MIL ON With DTC C1AC200

Service Category Audio/Visual/Telematics

Section Park Assist/Monitoring

YEAR(S)	MODEL(S)	ADDITIONAL INFORMATION
2021 - 2024	Sienna HV

Figure 1.

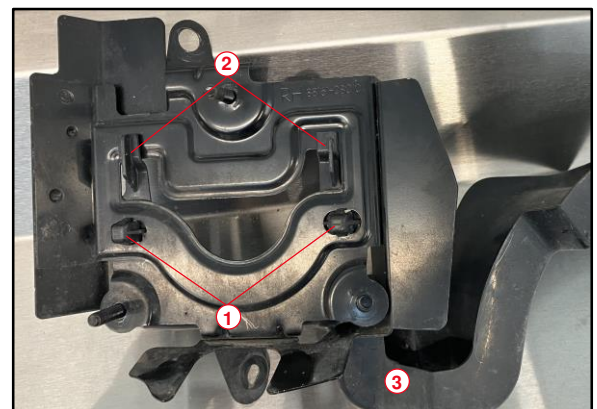
5. Remove the blind spot monitor cover from the bracket. Refer to Figure 1.

- A. Release the two cover clips.
- B. Slide the cover tabs out of the bracket.

Figure 2.

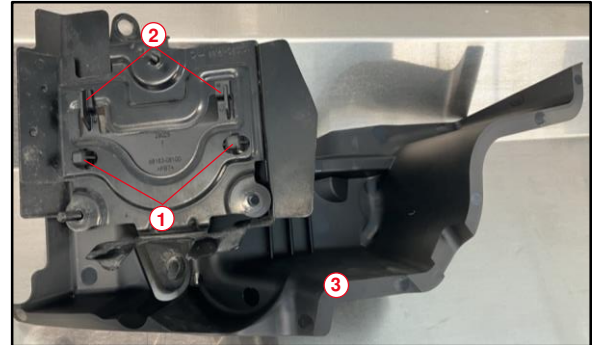
6. Attach the NEW blind spot monitor cover to the bracket as shown in Figure 2.
 - A. Slide the cover tabs through the bracket.
 - B. Secure the cover clips into the bracket.
